**Federal Highway
Administration**

Thank you for your June 29 letter requesting acceptance of your company's solar powered warning light/sign support systems as a breakaway supports for use on the National Highway System (NHS). Accompanying your letter was a report of crash testing done at Southwest Research Institute (SWRI) dated June 2000, and videos of the crash tests. On July 18 you provided additional information regarding a heavier configuration of warning system than the one that was tested.

- To prevent misunderstanding by others, this letter of acceptance, designated as number SS-90, shall not be reproduced except in full.
- K&K Systems Solar Panel Sign Supports are patented products and considered "proprietary." The use of proprietary work zone traffic control devices in Federal-aid projects is generally of a temporary nature. They are selected by the contractor for use as needed and removed upon completion of the project. Under such conditions they can be presumed to meet requirement "a" given below for the use of proprietary products on Federal-aid projects. On the other hand, if proprietary devices are specified for use on Federal-aid projects, except exempt, non-NHS

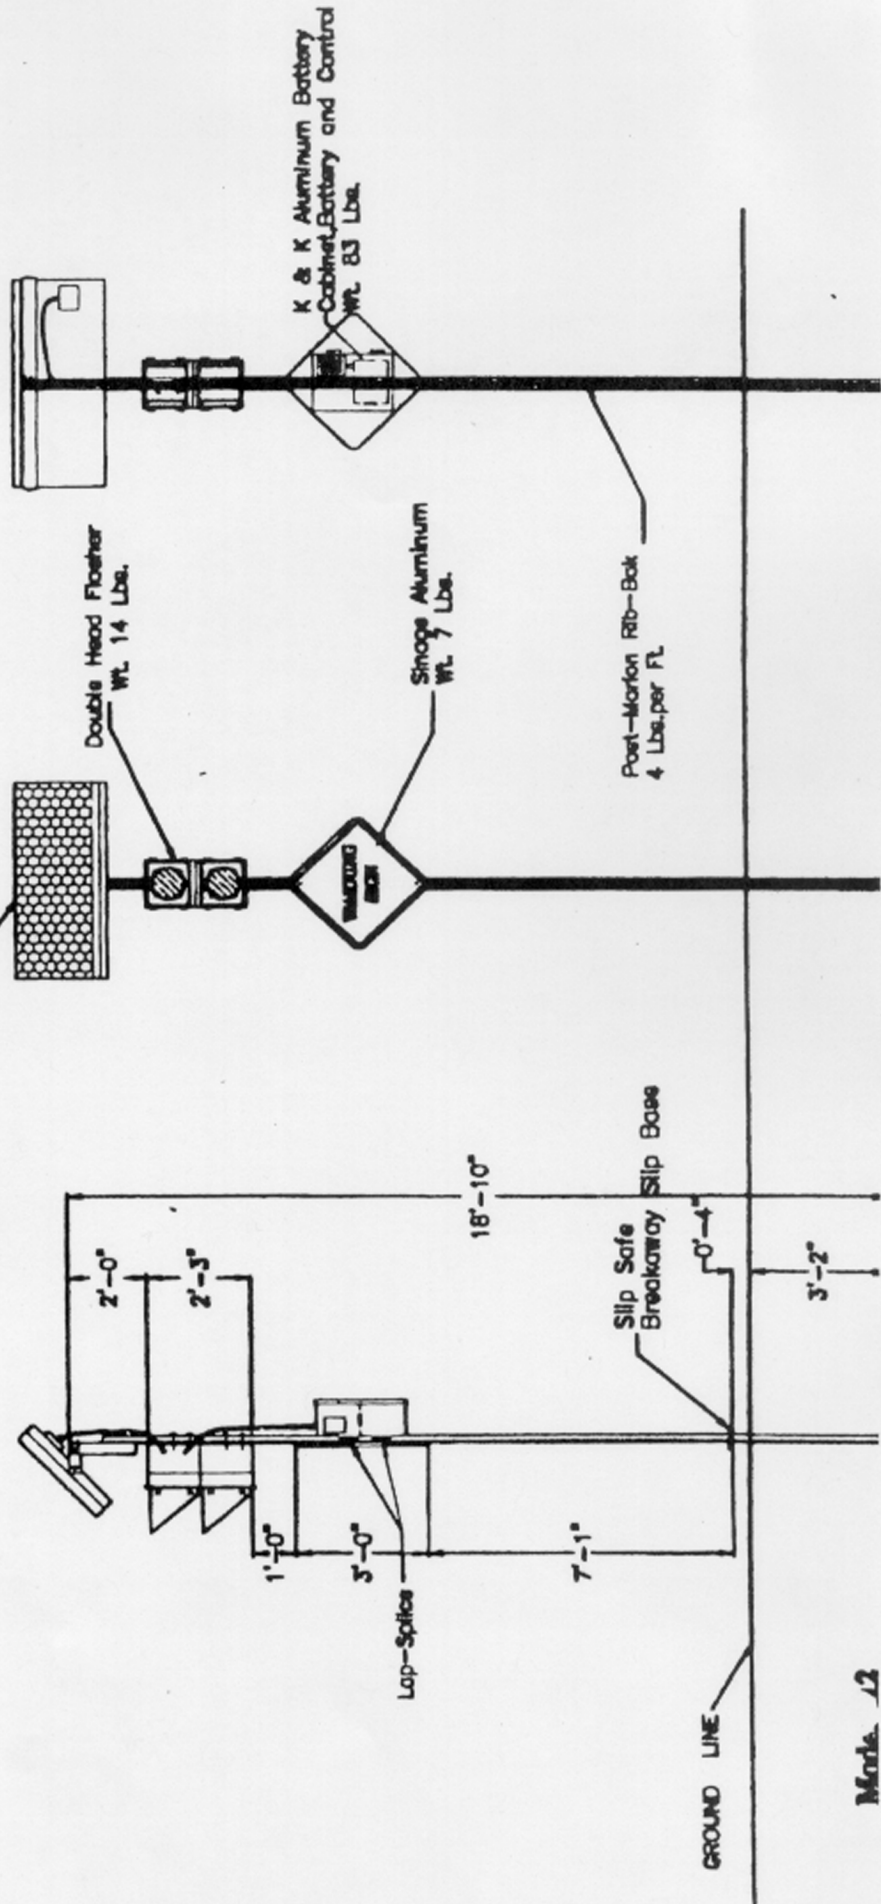
Two crash tests were conducted, one at 35 km/hr and another at 100 km/hr. The test articles were Model 112 K&K Systems Solar Panel Sign Supports as shown in Enclosure 1. They were mounted on Marion Steel "SLIP-SAFETM" breakaway slip bases. The two-bolt slip-bases for u-channel supports were previously accepted by the Federal Highway Administration (FHWA) (See acceptance letter SS- 69 dated 9-18-1996). The posts are 6 kg/m (4 pound-per-foot) u-channel sign supports of steel conforming to re-rolled rail steel specifications. Each test article consisted of the breakaway post, aluminum warning sign, aluminum battery cabinet/battery/controller, double head flasher, and 80 watt solar panel. The height to the top of the signpost was 4775-mm. The angled solar panel extended slightly above that height.

The tested supports met the change in velocity and stub height requirements of the AASHTO Standard Specifications and NCHRP Report 350. There were no deformations of the passenger compartment and no damage to the windshield. Therefore, this K&K Systems Model 112 Solar Panel Sign Support on Marion Steel slip-base supports are acceptable for use on the NHS within the range of conditions tested, when requested by a State. Because the supports were tested in standard soil and there was little or no motion of the stubs in the soil as a result of the test, this breakaway support will also be acceptable when placed in a concrete foundation in standard soil.
